ELECTRICAL DRAWING:

1	ISSUED FOR ADDENDUM #5	TYI	10/12/25
0	ISSUED FOR CONSTRUCTION	TYI	20/10/25
ISSUE/REVISION	DESCRIPTION	BY	DDMMYY

Project Title
**PROVINCIAL FIRE AND
LIFE SAFETY PROJECT -
VICTORIA HOSPITAL**

1 E1.1

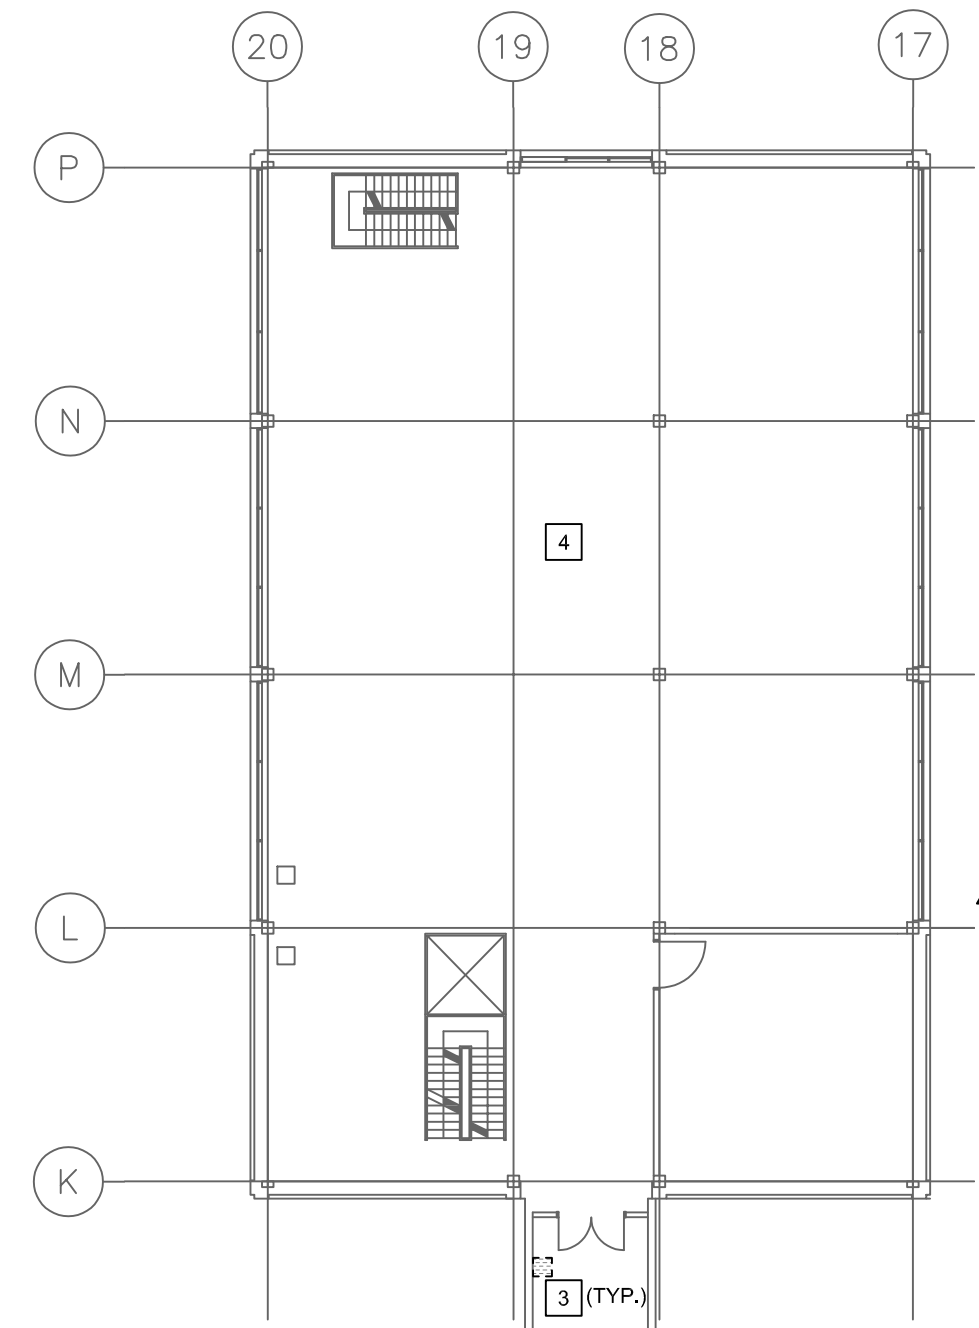
1. E1.1 CRAWLSPACE FLOOR PLAN- EAST, TUNNEL AND POWERHOUSE –
BASEMENT FLOOR PLAN - ELECTRICAL – DEMOLITION
 - a. Refer to attached drawing for revisions as clouded.
2. E1.2 CRAWLSPACE FLOOR PLAN – WEST – ELECTRICAL – DEMOLITION
 - a. Refer to attached drawing for revisions as clouded.
3. E2.1 CRAWLSPACE FLOOR PLAN- EAST, TUNNEL AND POWERHOUSE –
BASEMENT FLOOR PLAN - ELECTRICAL – NEW CONSTRUCTION
 - a. Refer to attached drawing for revisions as clouded.
4. E2.2 CRAWLSPACE FLOOR PLAN – WEST – ELECTRICAL – NEW CONSTRUCTION
 - a. Refer to attached drawing for revisions as clouded.
